HEBER CITY PLANNING COMMISSION

Meeting date: March 6, 2014

Re: TSC Site at 400 East 1200 South

Subject: Tractor Supply – Commercial Concept Review

SHEET
C1

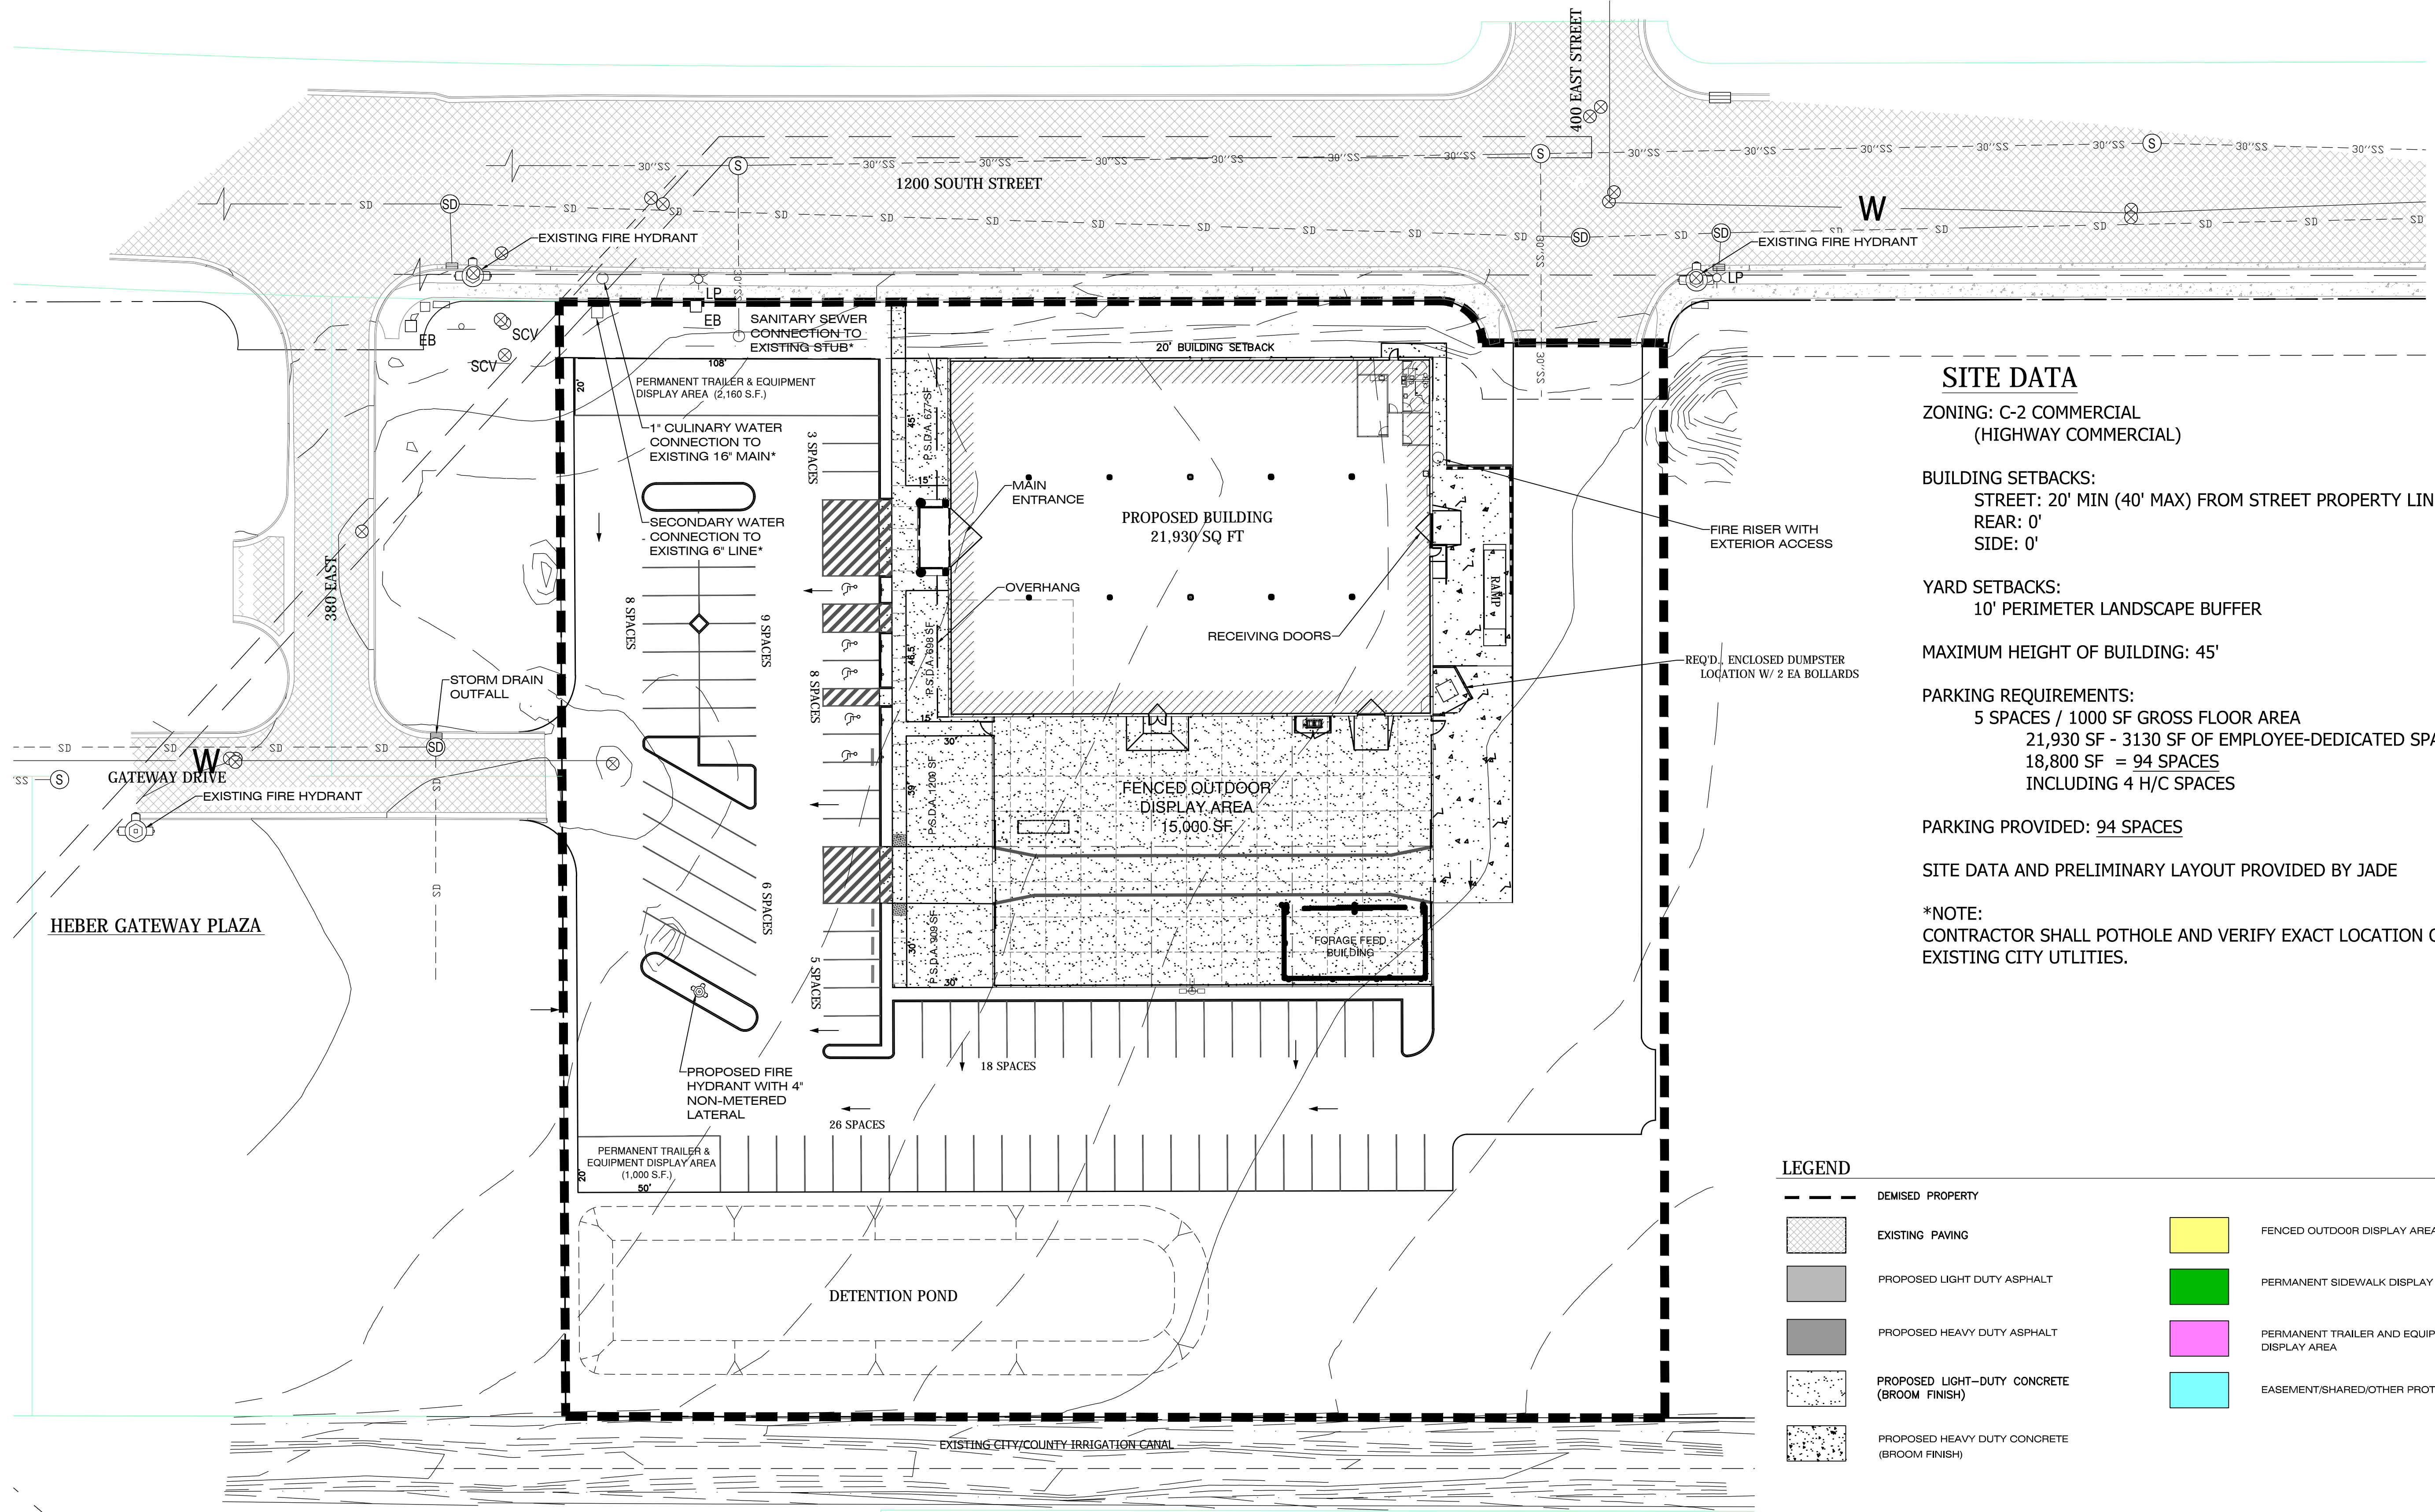
- Two access are recommended for the project. Gateway Phase 1 has not yet obtained final acceptance as a constructed subdivision. This is a private driveway and is not plowed or maintained by the City. Tractor Supply Company will need to get permission and an access/maintenance agreement from the current owners of Gateway Phase 1 for use of this road.

- The sewer lateral needs a clean-out in the park strip on 1200 South.
- Add a note to the plan stating that the existing utility locations need to be potholed and the location field verified.
- The existing ADA ramps on the south side of 1200 South at 400 East need to be updated per the current Heber City Standard Specifications and Drawings. The existing ramps do not have the required truncated dome panels.
- Should the sidewalk at 380 East or 400 East be extended and connected to the proposed building site?
- There is an empty common area parcel in the adjacent Gateway project between the property and 380 East. Could the developer use this piece to increase parking and eliminate this empty space?

- A storm drain plan and associated storm drain report needs to be submitted. If discharge into the flood channel is proposed, the high water elevation of the channel needs to be considered in the overall design and elevations of the onsite system. A stormceptor type water quality device will be required.
- The fire hydrant should be installed with a standard 6 inch line. The new fire hydrant could possibly be moved north to the next island to reduce the length of new line needed.

A201

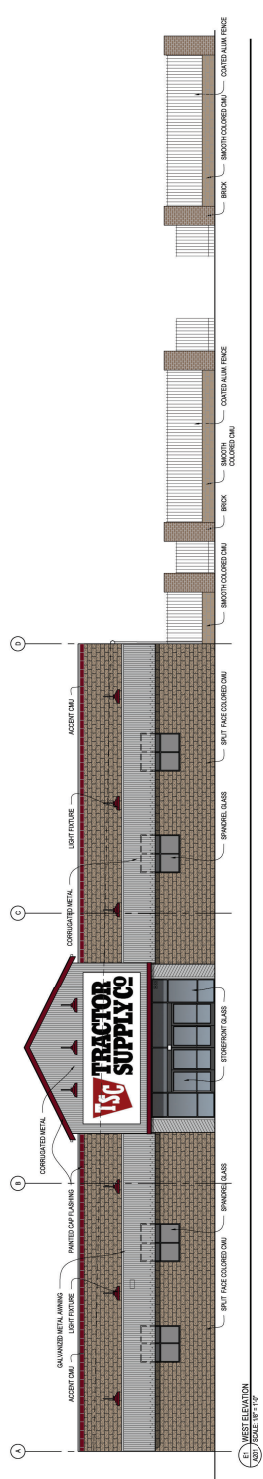
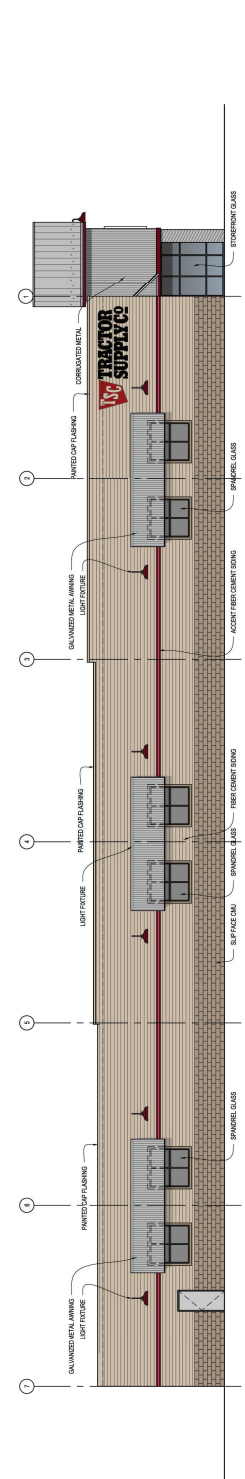
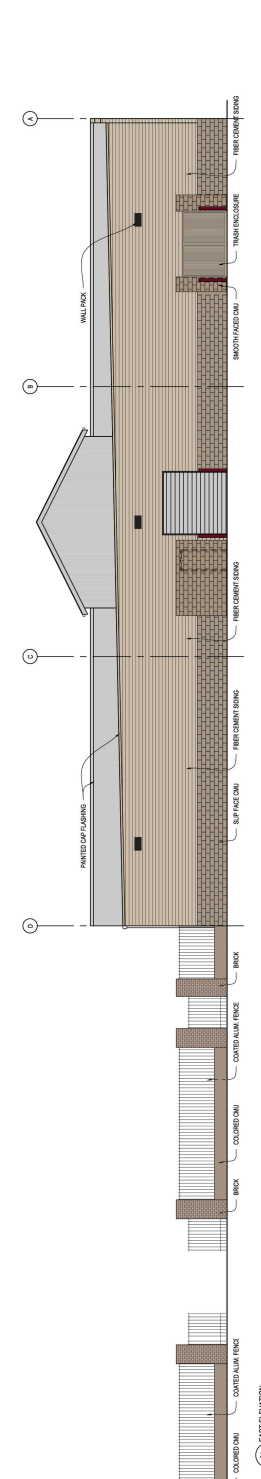
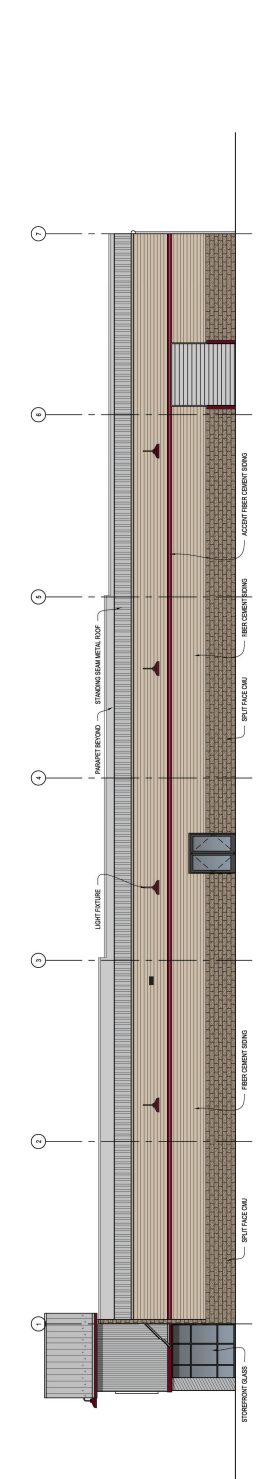
1. Section 307 of the Design Criteria (this section requires a 24 inch modulation in the building for each 50 feet of horizontal wall area)
2. Provide a landscaping plan, for non-parking areas, including 3' caliper Honey Locust or similar street trees be planted each 50 feet of frontage along 1200 South.

3. Developer submit evidence of authorization for utilization of the Heber Gateway Plaza Phase 1 Driveway.
4. The design criteria prohibits metal standing seam and limits metal shingles for the wall surface; the proposed door elevation includes corrugated metal, and the Planning Commission should determine if the design criteria requirement is met with the proposal.
